CITY OF PORTLAND, MAINE

Project Name: 197 Spring Street Renovation and Alteration
Address: 197 Spring Street
Applicant: WAIT, LLC
Planner: Matthew Grooms, Planner

PLANNING BOARD REPORT PORTLAND, MAINE

9-Unit Rooming House to 7-Unit Condominium Conversion
197 Spring Street
Level III Site Plan
2017-061
WAIT, LLC

Figure 4 (At Right): Proposed Site Plan

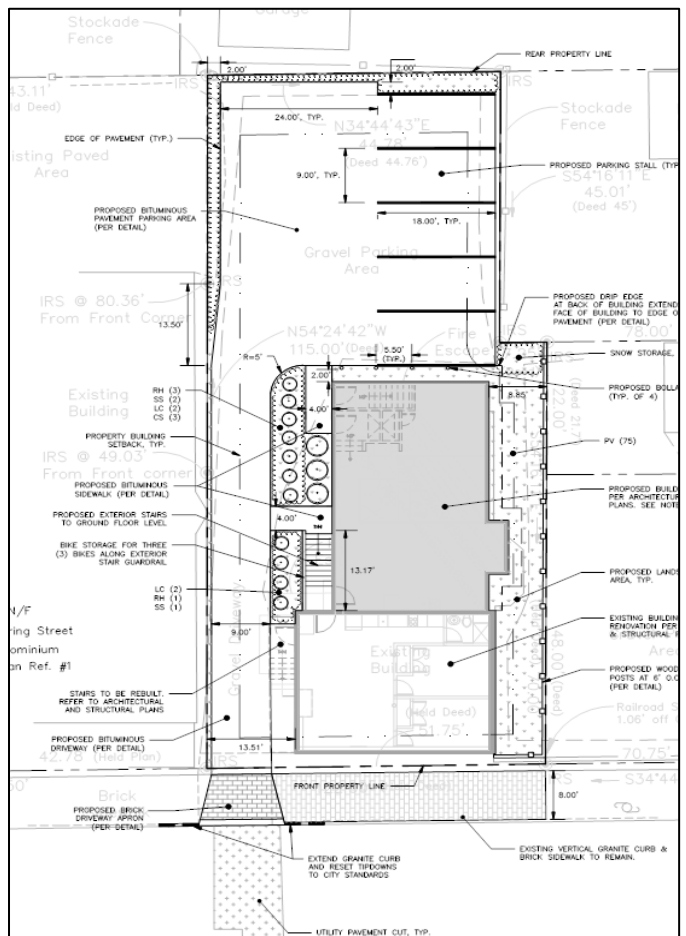
The final plans include a 9' foot wide driveway, 24' foot wide drive aisle within the rear parking area and five standard sized 9' by 18' parking spaces immediately adjacent to the easterly property line. Additionally, the applicant is proposing a new brick driveway apron that will tie in with the existing vertical granite curb and brick sidewalk. Mr. Errico has reviewed the applicant's submittals and has asked for confirmation that the new driveway apron meets the required cross-slope for pedestrian access of no greater than two percent. Further, planning staff have asked the applicant to consider reducing the five standard sized parking spaces to compact spaces which would allow for further buffering between this development and the adjacent property (*Attachment 1*).

Division 20 of the land use ordinance provides an exception for the off-street parking requirement for the first three units in the R-6 zone and a 1:1 requirement thereafter. Per the ordinance, only four off-street spaces are technically required. The applicant has elected to provide five off-street spaces. In order to provide additional buffering between this development and the adjacent property to the east, city staff have requested that the applicant consider striping compact parking spaces as opposed to standard sized parking spaces. Mr. Errico has verbally stated that he would support a waiver to allow compact parking spaces.

Manual standard (*Section 1.14*) which requires that a standard parking space be 9' x 18', that substantial justice and the public interest are secured with the proposed variation in this standard, and that the variation is consistent with the intent of the ordinance. The Planning Board waives the *Technical Manual* standard (*Section 1.14*) to allow five 8' x 15' spaces with a vote of 7-0;

2. The applicant shall submit a final driveway apron detail meeting *Technical Manual* standards for review and approval by the Department of Public Works; and

Figure 5: North and West Building Elevations

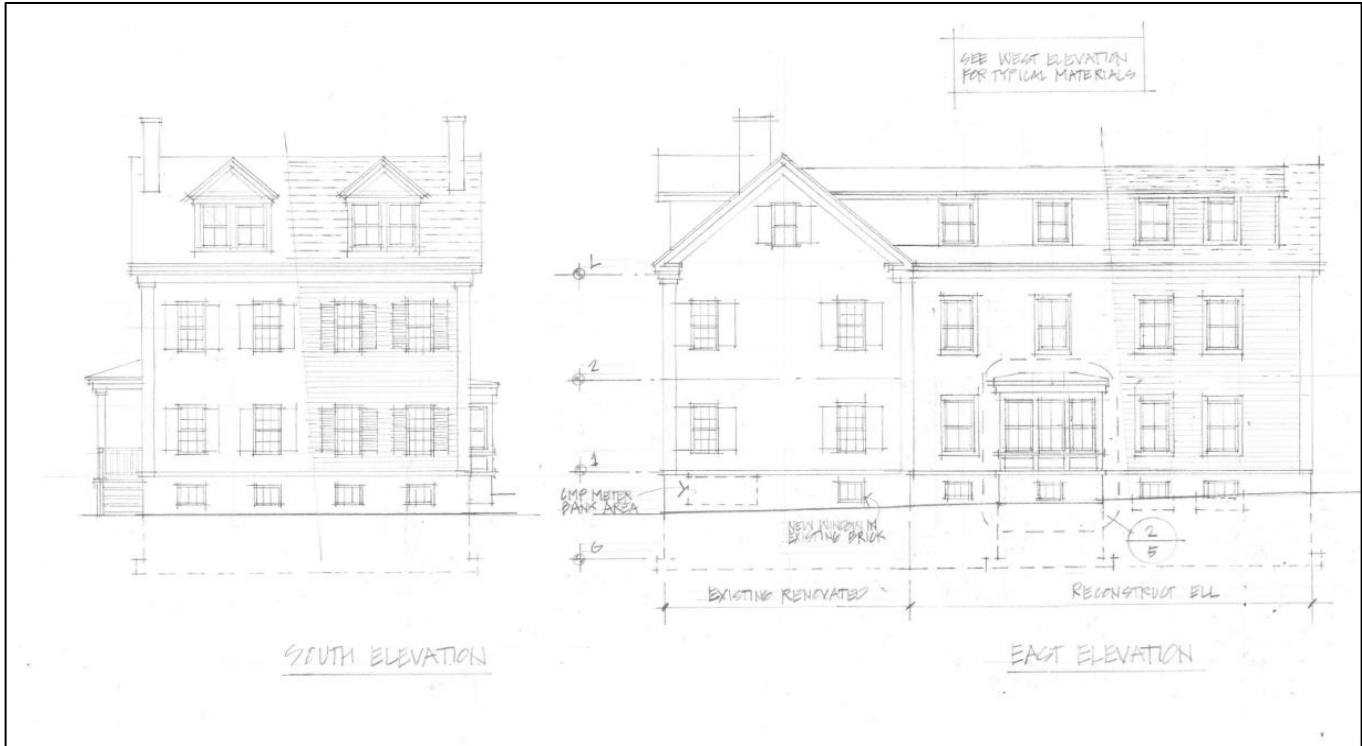
1. Would the applicant consider the installation of compact parking spaces as opposed to standard sized parking spaces to provide additional buffering against the adjacent property? The City's Traffic Engineering Consultant has verbally indicated that he would support a waiver of this requirement.
2. Is the applicant proposing any new exterior lighting? If so, a photometric plan and associated lighting details sheets will be required demonstrating acceptable light trespass.
3. What will the height of this building be? Please provide a revised building elevation that includes spot grades at building corners and building dimensions.

3. The applicant shall provide a photometric plan and associated detail sheets which demonstrate acceptable light trespass;
4. The applicant shall provide revised elevation sheets with spot grades and building dimensions that illustrate building height;
